**SUNDRY NOTICES AND REPORTS ON WELLS**

### **GCU Well Work Procedure**

**GCU 163E**

# **Conditions of Approval:**

Wellbore Diagram

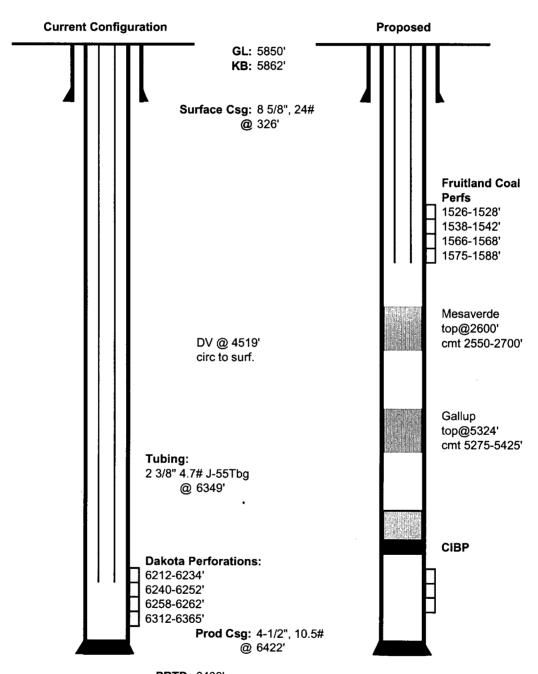
1. Operator's reported Mesaverde top is actually the Chacra top in This well bore. The Cliff House top 3186' should be used for the Mesaverde plug in this procedure.

2. This well is in an area where the Chacra formation is non-Productive. A Chacra plug is not required to be set in this well bore.

Spot 150' balanced cement plug in casing across Mesaverde From 3085' to 3235'.
